State of New Mexico
Energy, Minerals and Natural Resources

WELL API NO. 30-015-05371
5. Indicate Type of Lease STATE <input type="checkbox"/> FEE <input type="checkbox"/>
6. State Oil & Gas Lease No.
7. Lease Name or Unit Agreement Name Skelly Unit
8. Well Number 81
9. OGRID Number 269324
10. Pool name or Wildcat Grayburg Jackson; SR-Q-G-SA

SUNDRY NOTICES AND REPORTS ON WELLS (DO NOT USE THIS FORM FOR PROPOSALS TO DRILL OR TO DEEPEN OR PLUG BACK TO A DIFFERENT RESERVOIR. USE "APPLICATION FOR PERMIT" (FORM C-101) FOR SUCH PROPOSALS.)	
1. Type of Well: Oil Well <input type="checkbox"/> Gas Well <input type="checkbox"/> Other <input checked="" type="checkbox"/> INJECTION	
2. Name of Operator Linn Operating, Inc	
3. Address of Operator 600 Travis, Suite 5100, Houston, TX 77002	
4. Well Location Unit Letter P : 810 feet from the S line and 660 feet from the E line Section 23 Township 17S Range 31E NMPM Eddy County	
11. Elevation (Show whether DR, RKB, RT, GR, etc.) 3871' GR

Well Name	Skelly Unit	Well No.	#81
Field		API #:	30-015-05371
County	Eddy	Prop #:	
State	New Mexico	Zone:	Grayburg Jackson
Spud Date	6/2/1960		810'FSL 660'FEL
GL	8/6/1910		Sec 08 T25S R29E
KB	3875

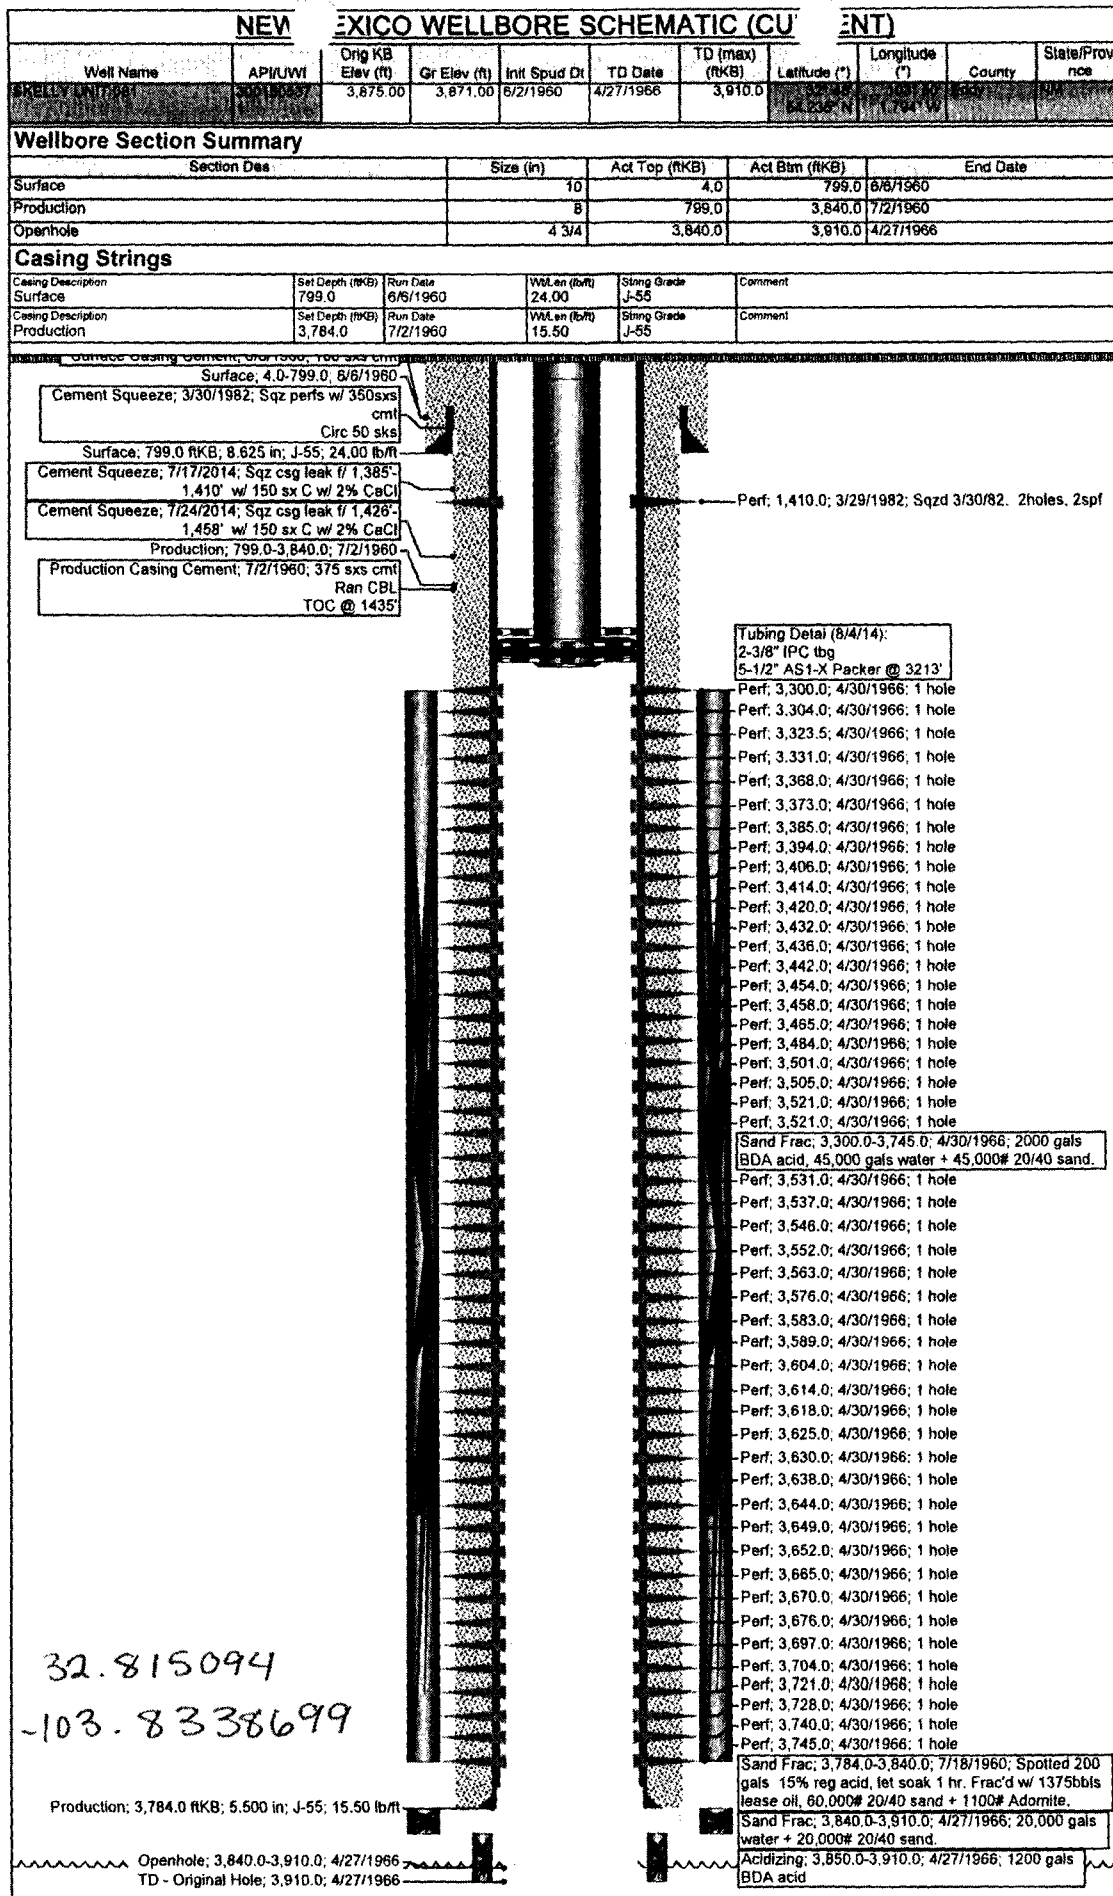
4. Perf & Sqz 20 sx cmt @ ~~60'~~ Surface.
100'

3. Perf & Sqz 50 sx cmt @ ~~850-730'~~ *700'* WOC & Tag (Shoe & T/Salt)

← ADD A PLUG @ 1485' - TO 1385' (TOP OF CMT) WOC & TAG

← ADD A PLUG @ 2900' - TO 2800' - (POVERS QUEEN)
